ANADROMOUS WATERS CATALOG/ATLAS
CORRECTION FORM

MAP: Kodiak B1 & B2 (38)

WATERWAY NUMBER: 259-41-10010
25941-10010-2010 & 2013

259-41-10010 —
Stream channel change

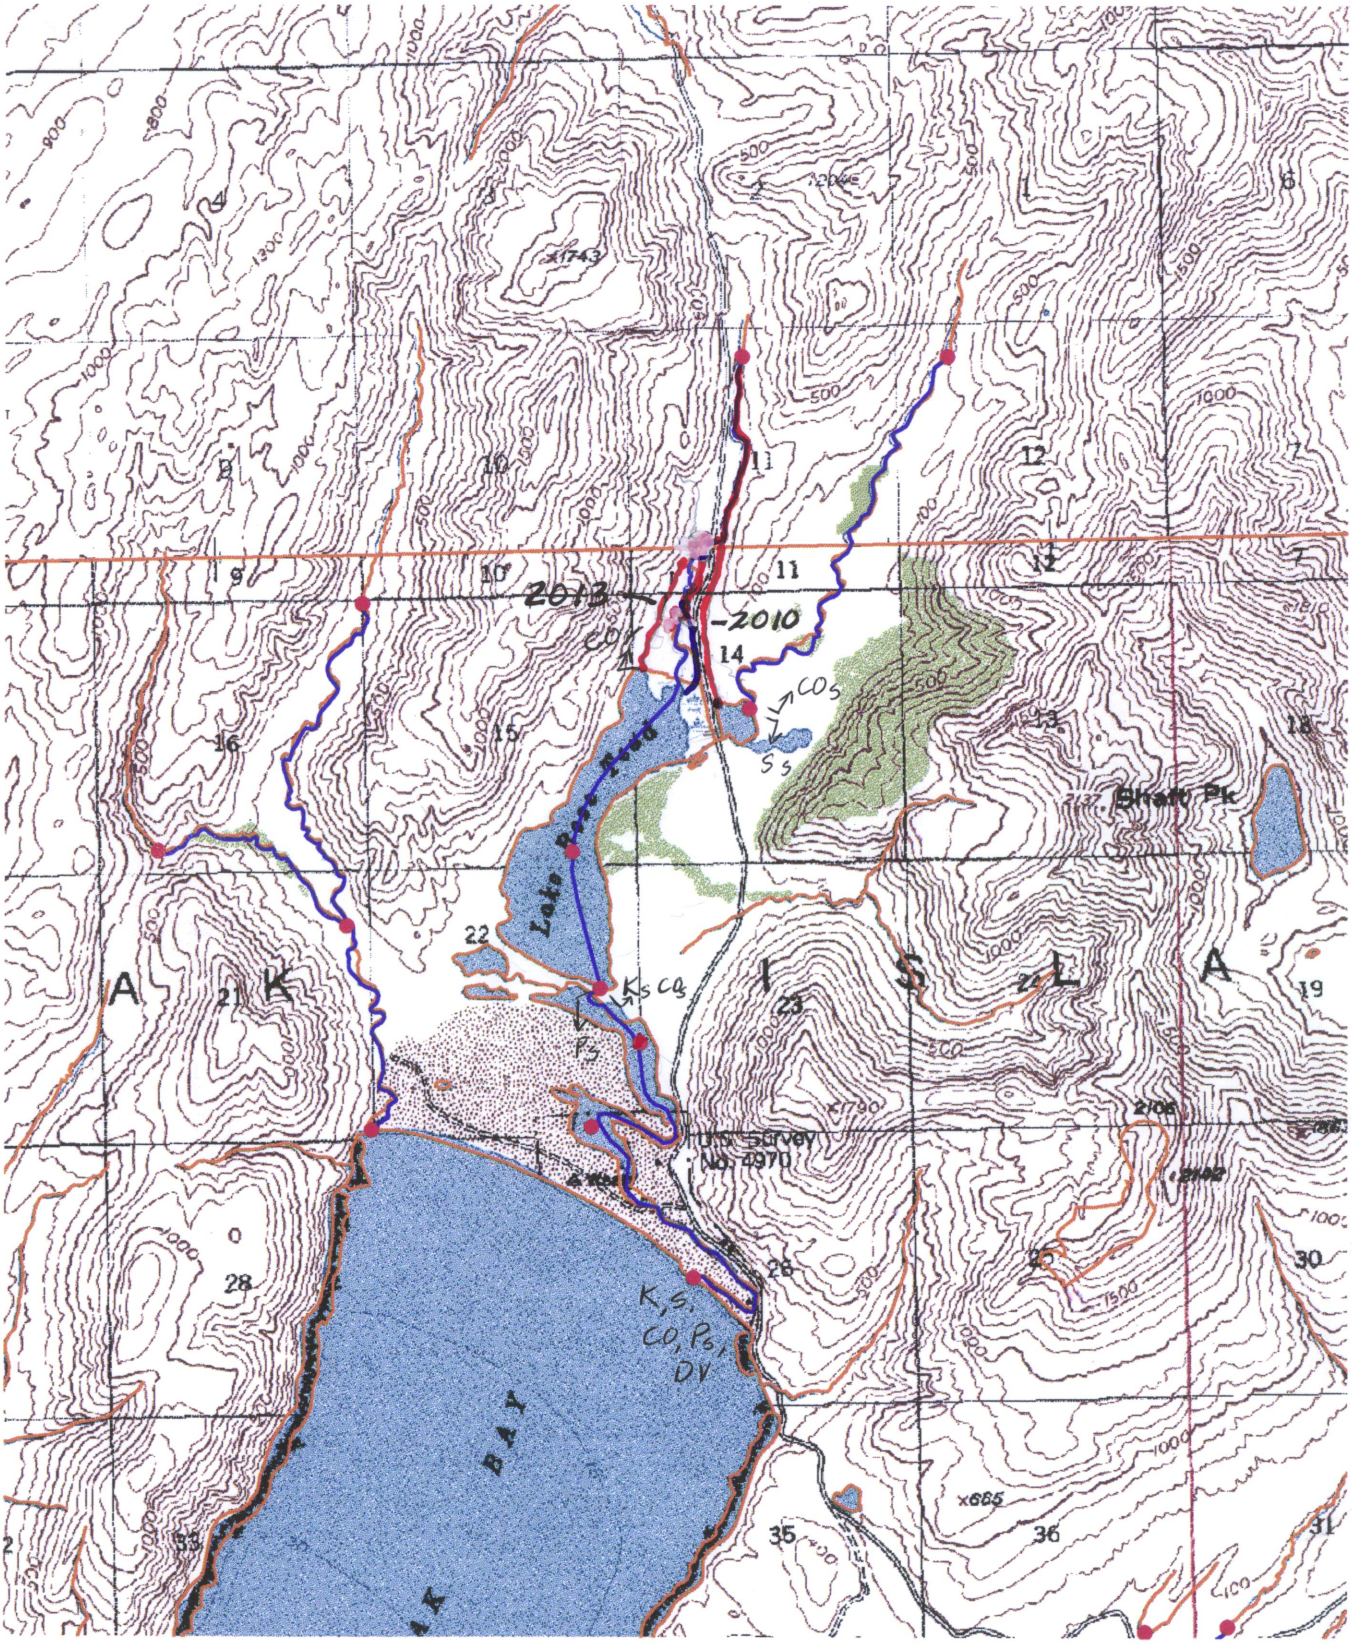
AZ-added → 259-41-10010-2010 Arc# 3285
AZ-added → 259-41-10010-~~2010~~ 2013 Arc# 3284
D1 — Shortened → 259-41-10010

Kodiak B-1 & B-2 of 38

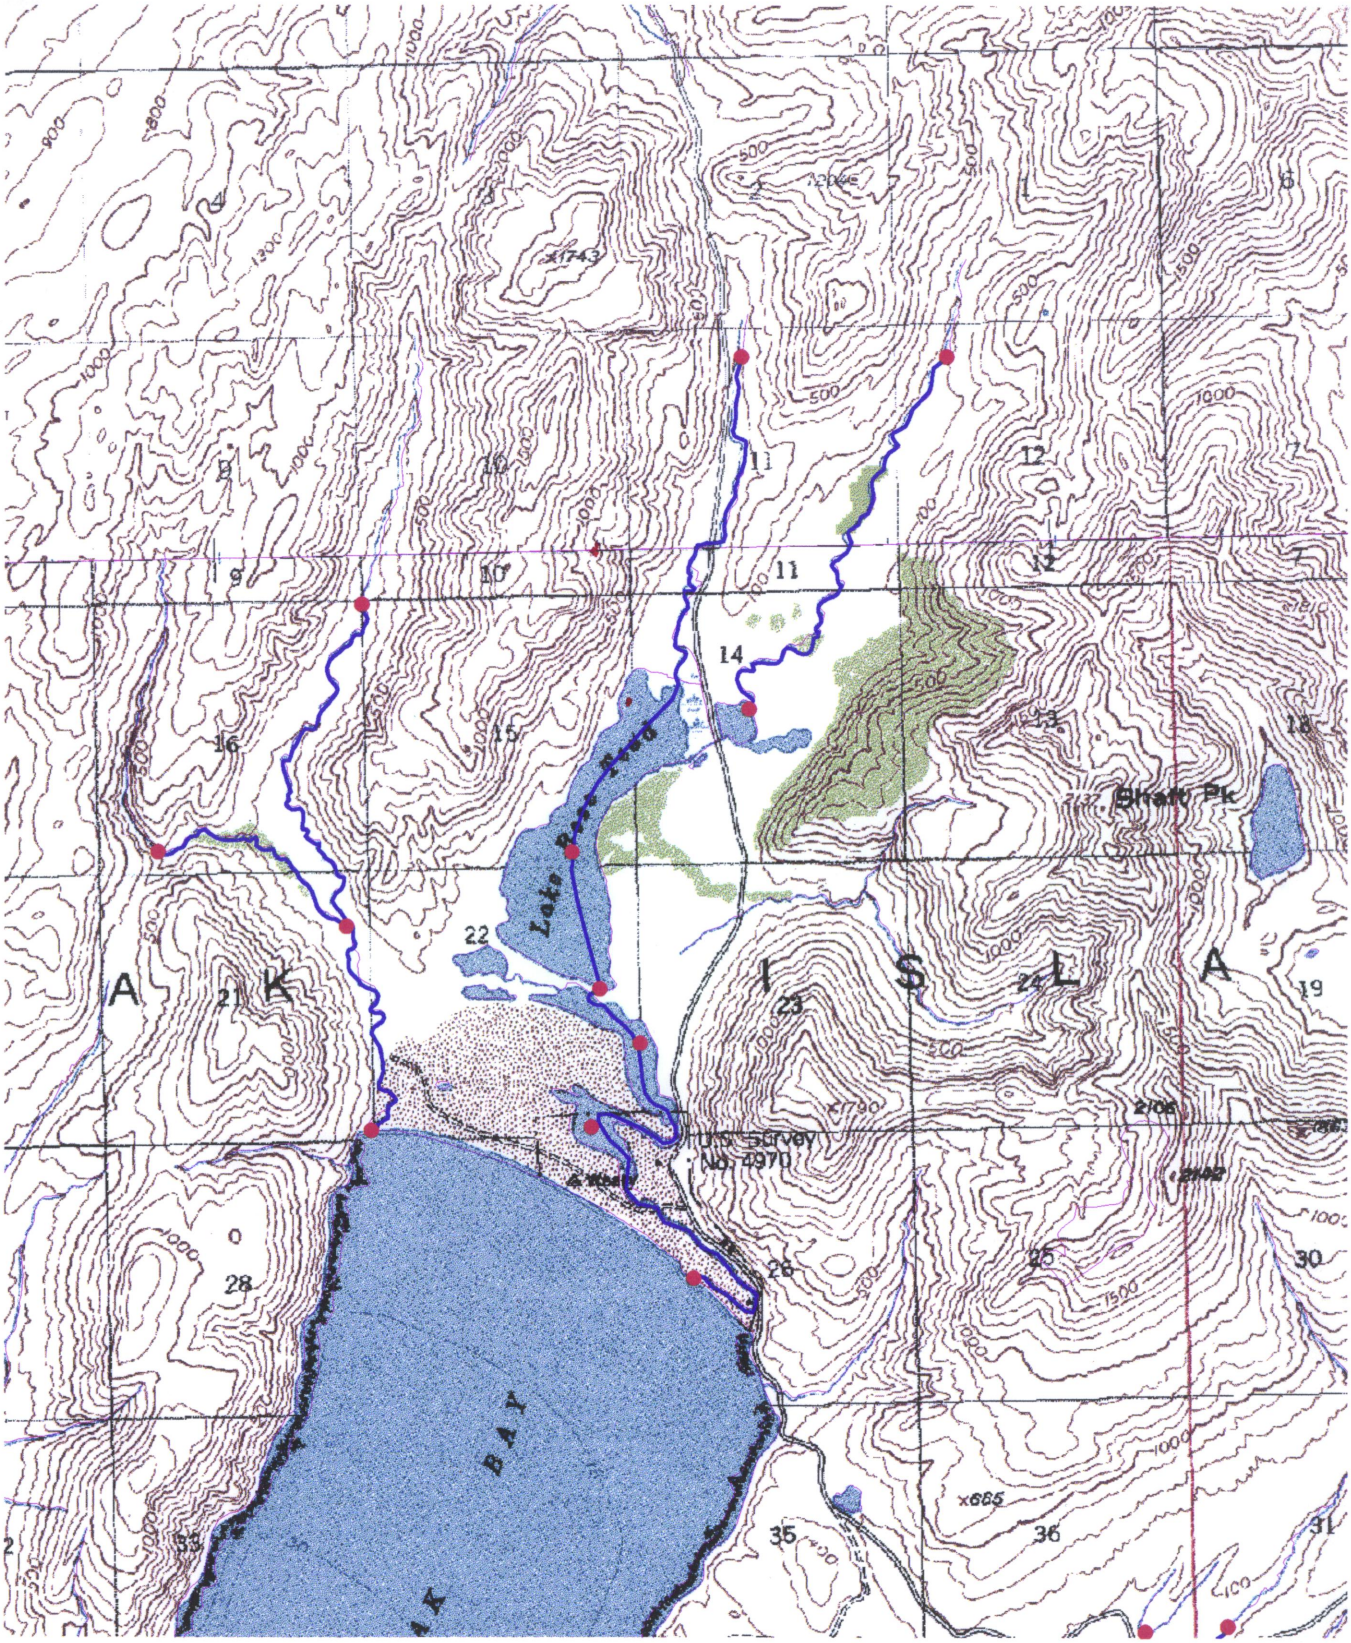
Comments per W. Dolezal 2/15/00

Spawning Coho observed here 10/25/99

Spawning Sockeye in this area

Rearing Coho per W. Dolezal

Need new stream to East of road (main channel). Channel shown still has fish but is not the main channel.
